**CITY OF DANA POINT
PLANNING COMMISSION
AGENDA REPORT**

SUBJECT: PRELIMINARY REVIEW (PA20-0025) FOR THE DEMOLITION OF AN EXISTING RESIDENCE, LOT MERGER, ADDITION OF BETWEEN TEN AND FOURTEEN FEET OF FILL FOR THE DEVELOPMENT OF A TRIPLEX (DUPLEX AND DETACHED SINGLE FAMILY RESIDENCE) ON A LOT LOCATED AT 34456 VIA GOMEZ.

RE: Preliminary Review PA20-0025 - 34455 via Gomez, CA 92624

SITE PLAN

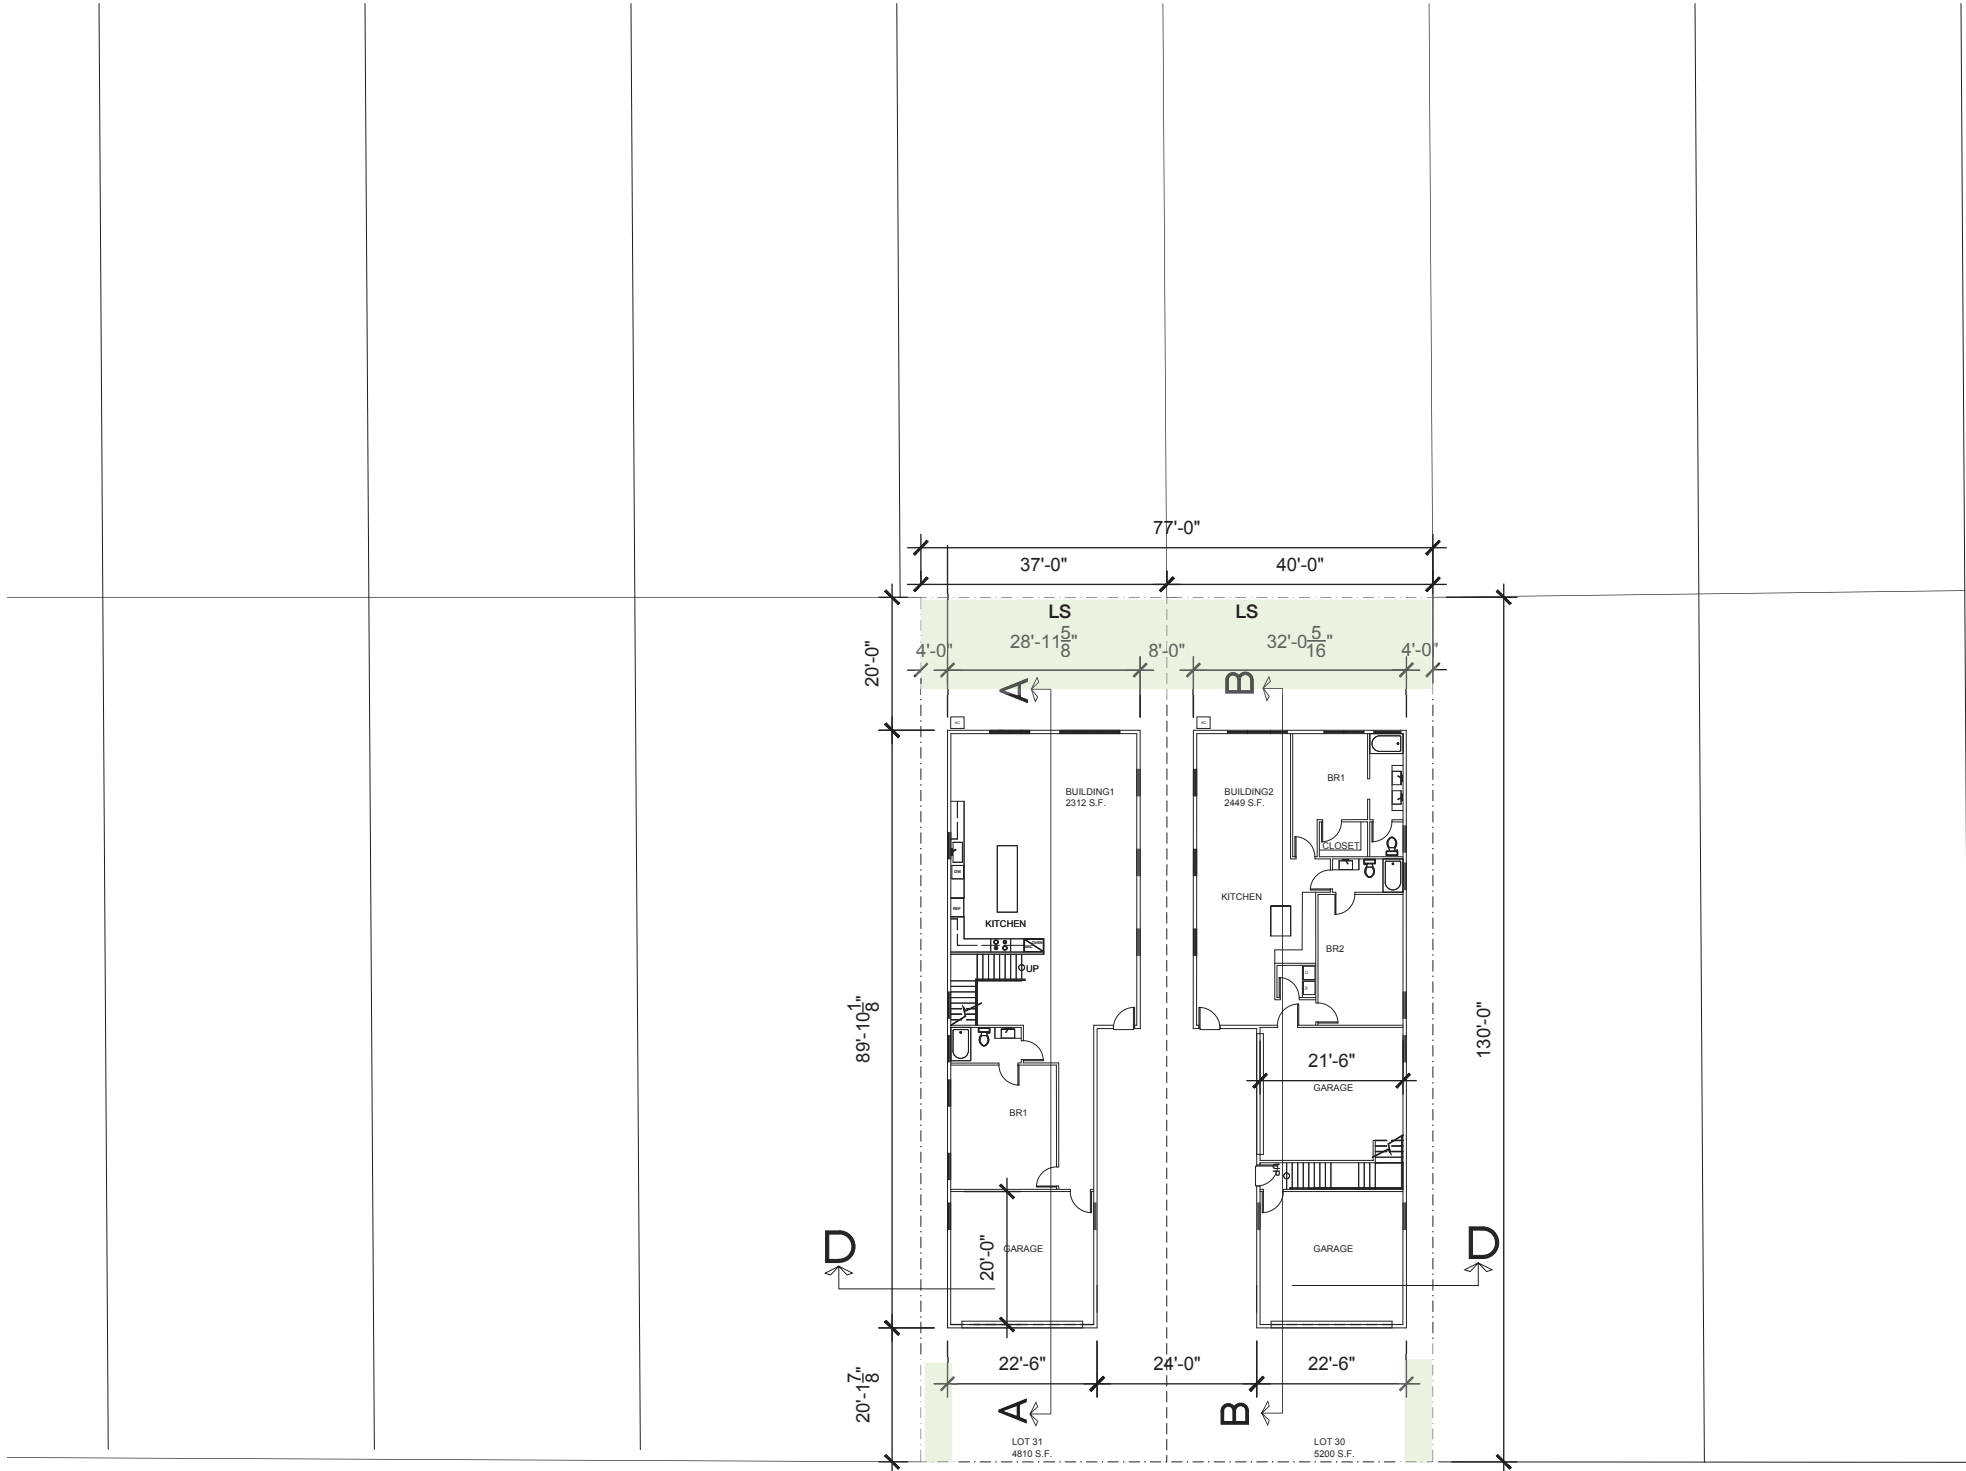
b. The Site Plan is incomplete and all applicable setbacks, property lines, existing public improvements, building separations need to be provided and clearly labeled.

c. On the Site Plan please accurately show the existing topography, the proposed finished pad, and the finished floor elevations, for both the garages and the main structures.

Response: The plans have been revised to provide a Conceptual Grading Plan and a Conceptual Drainage Plan. All plans have appropriate setbacks, property lines, existing public improvements and building separations shown.

Response: The plans have been revised to provide a Conceptual Grading Plan and a Conceptual Drainage Plan. All plans have appropriate existing topography, proposed finished pad and finished floor elevations shown, for both the garages and the main structure.

BUILDING1 NORTH ELEVATION

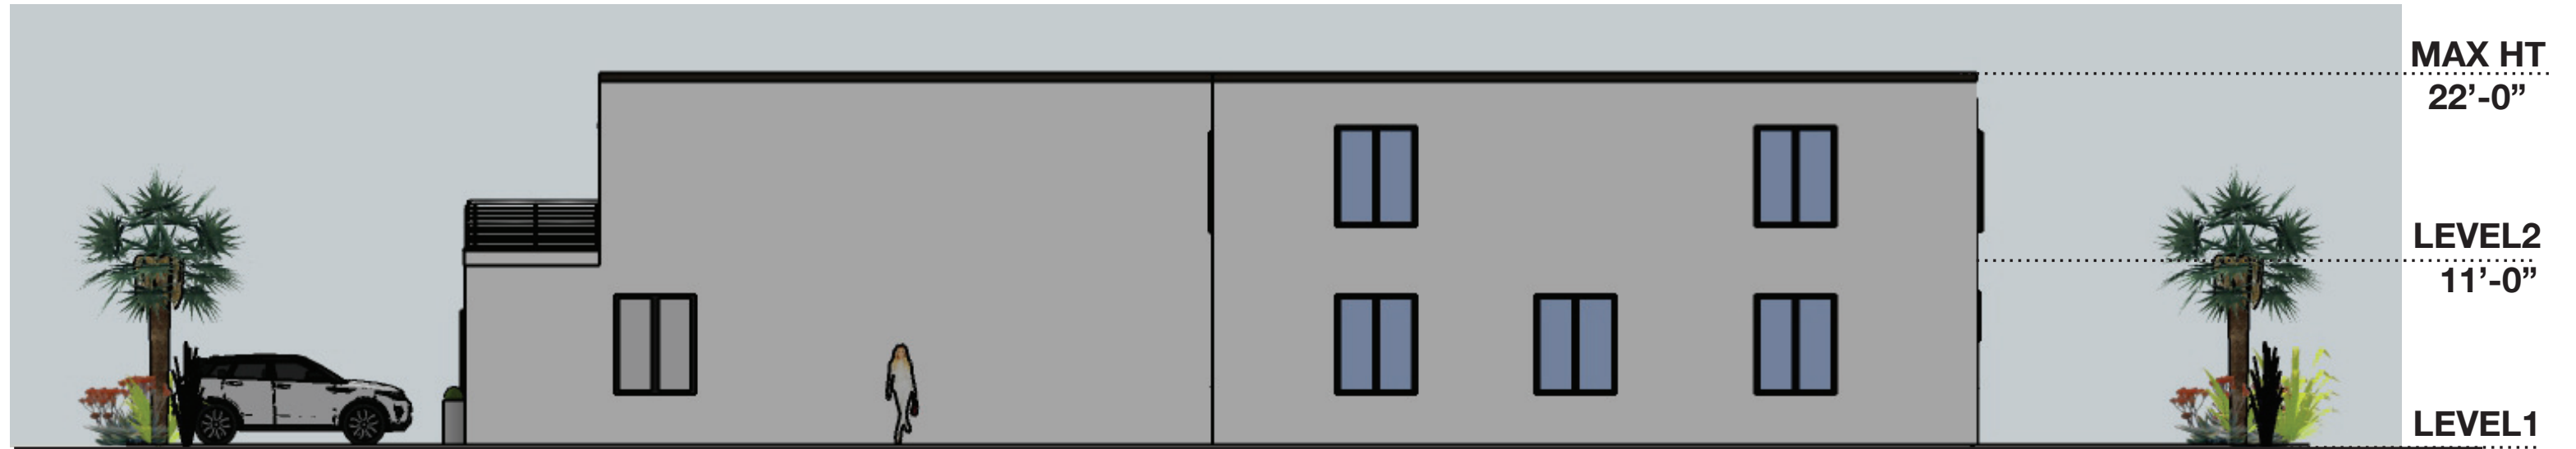
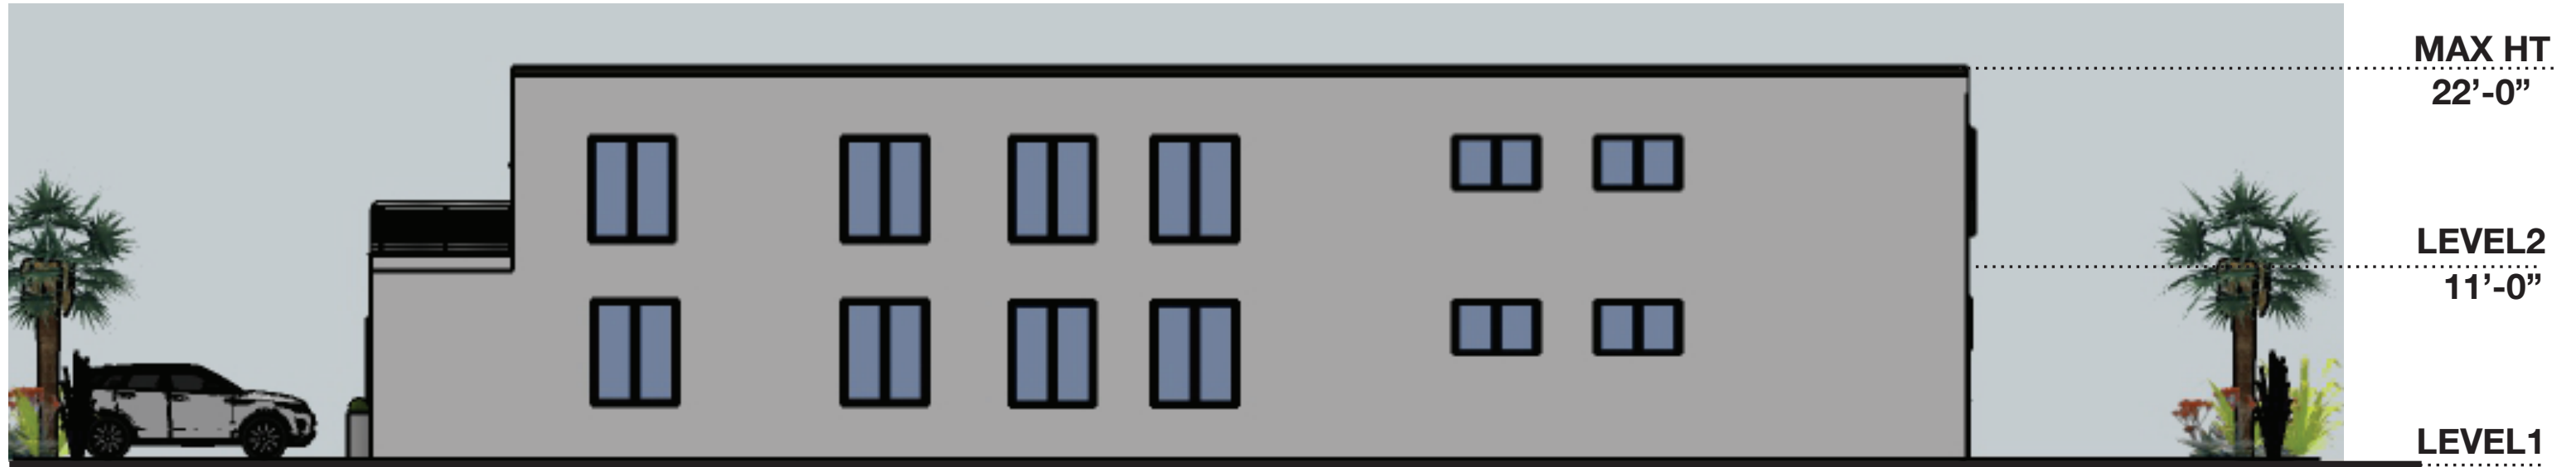
e. Please provide elevations and cross sections that illustrate and identify existing topography elevations, proposed pad elevations, maximum height elevations, and roof pitch.

Response: Noted, please see architectural drawings for building height.

34456 VIA GOMEZ, DANA POINT, CA 92624
CONCEPT GRADING PLAN
A.P. 123-152-48 SHEET **1 of 1**

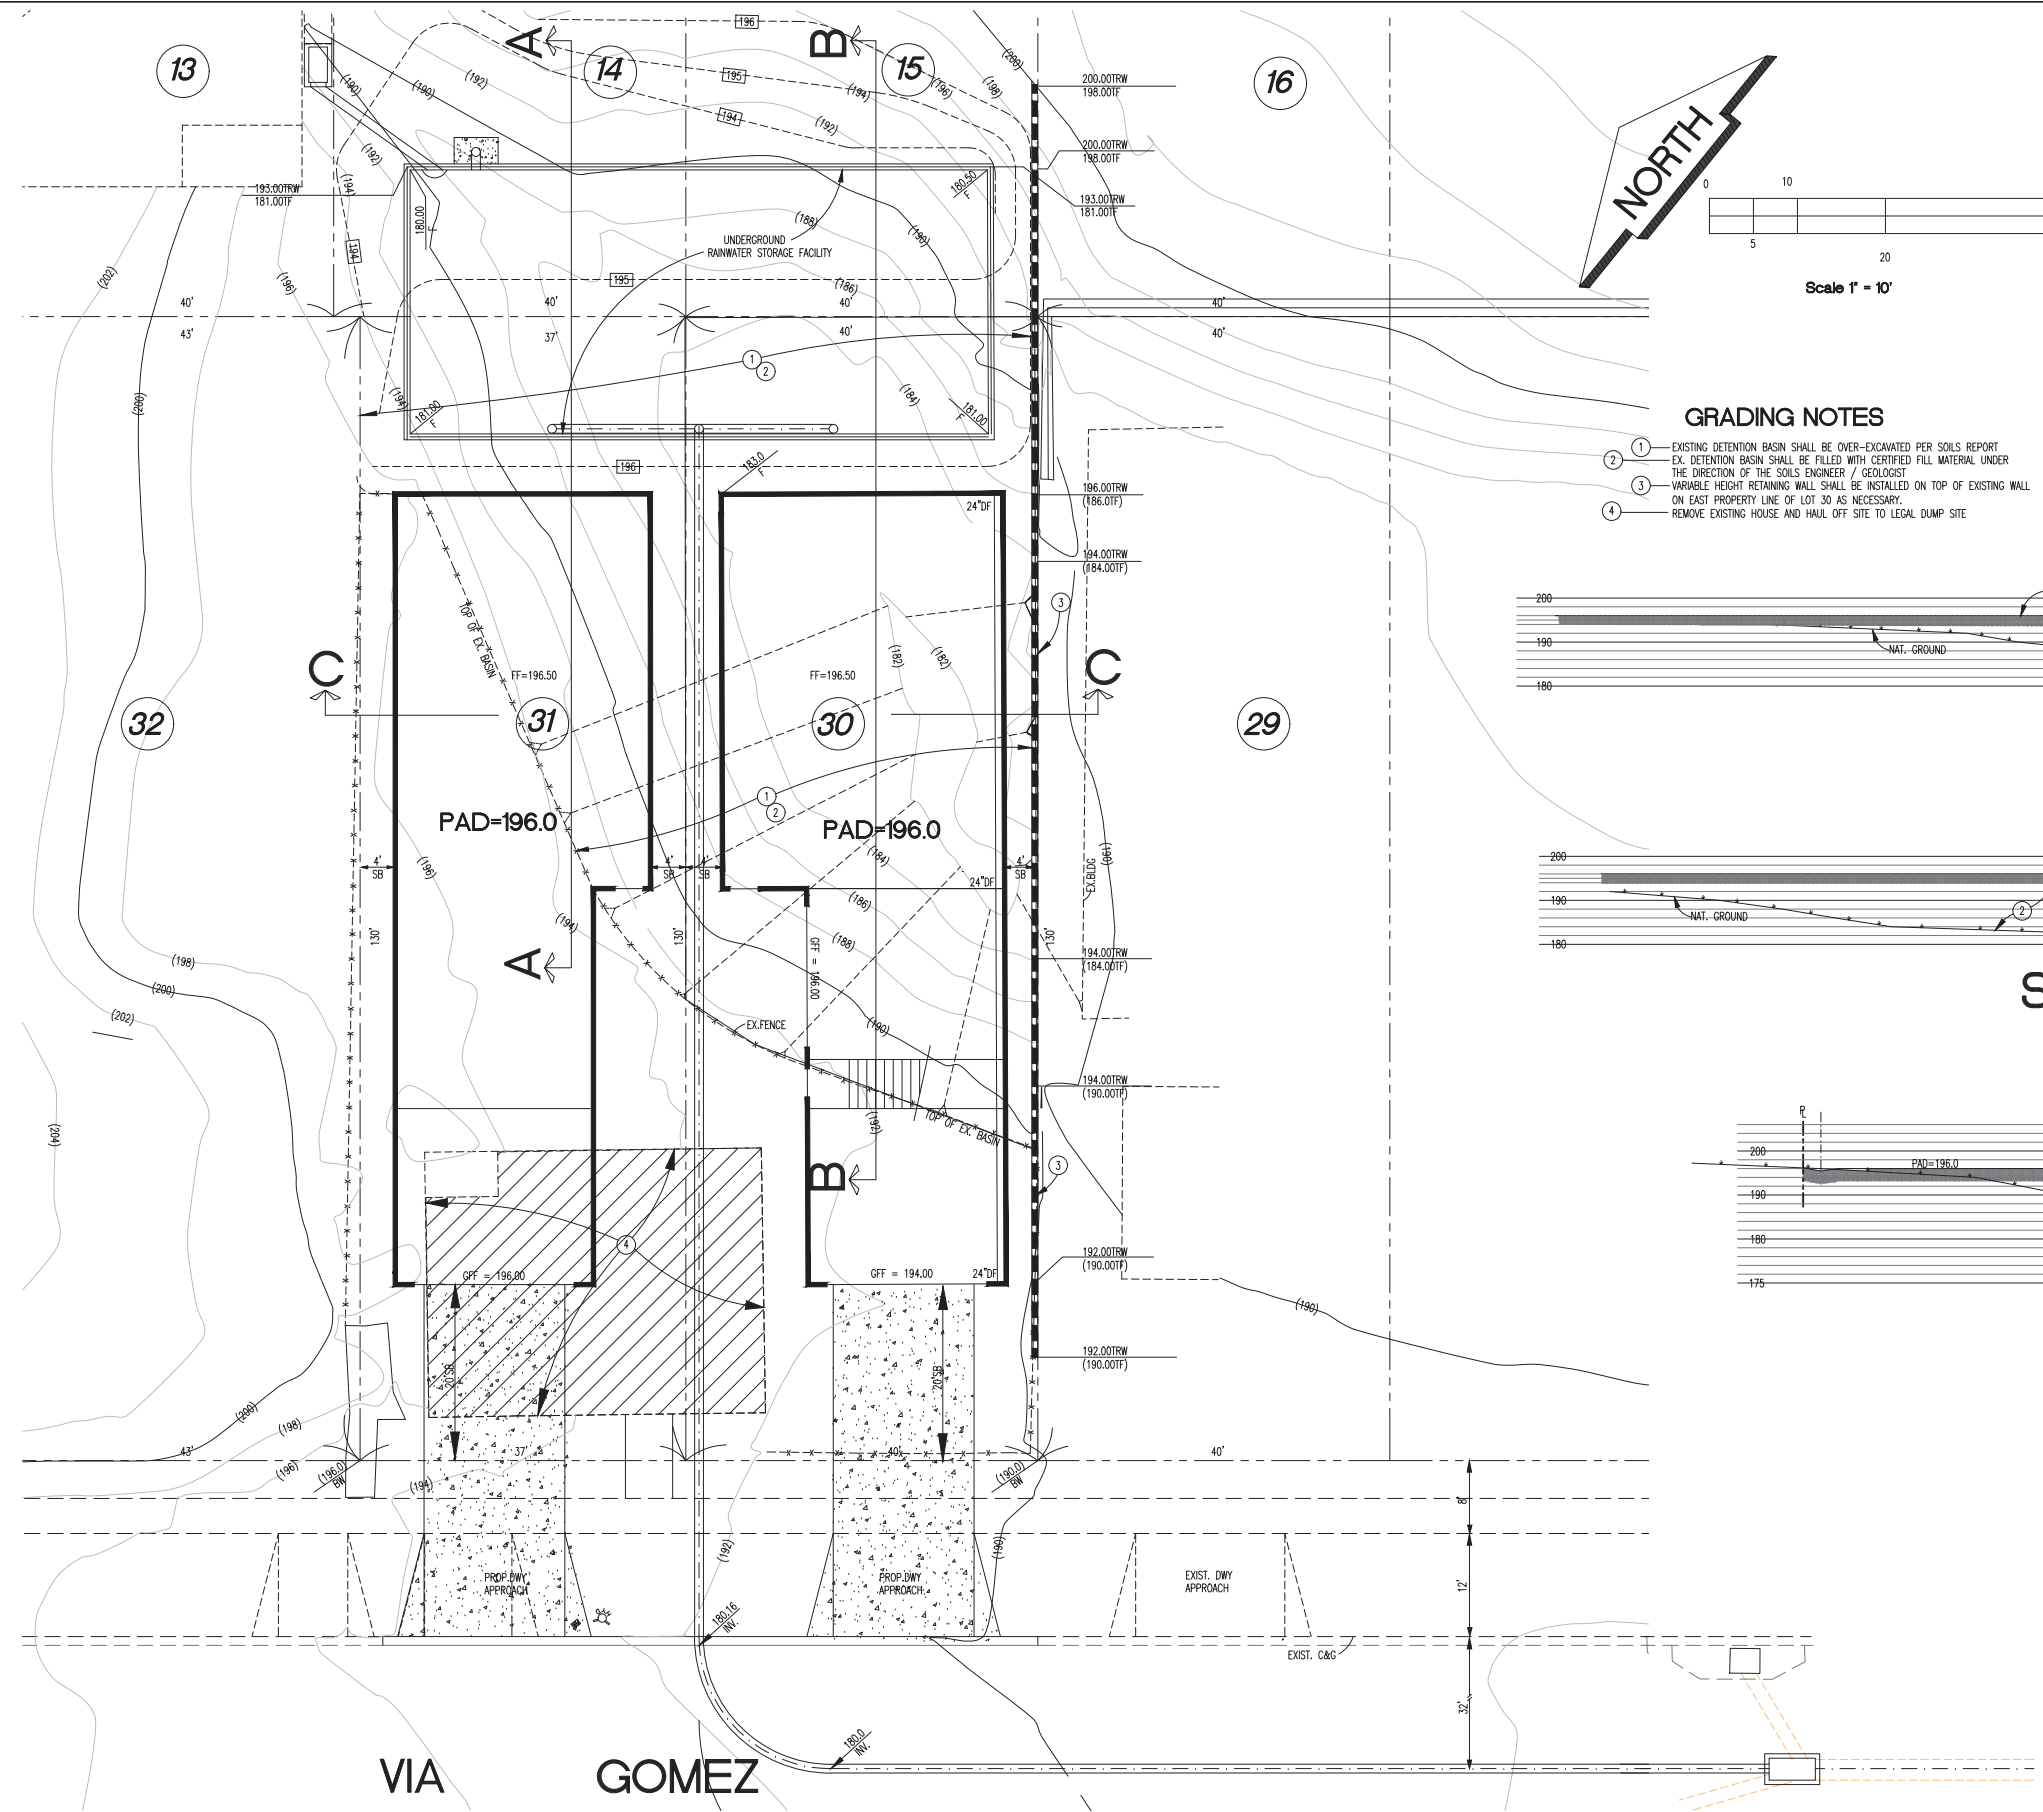
- 3) *The preliminary grading plan inaccurately illustrates the existing topography and the lowest point of the site that the building touches on both lots: essence, where you measure your building height from has been omitted.*

- 4) *Please provide the proposed finished pads for both the garages and the main structures on the preliminary grading plan.*

- 5) *Please clearly indicate the amount of fill proposed for each of the lots.*

Response: Plan has been revised per your comment.

Response: This information has been added to the revised Concept Grading Plan and the Concept Drainage Plan.

Response: The fill amount will be depicted on conceptual grading plan in next submittal.
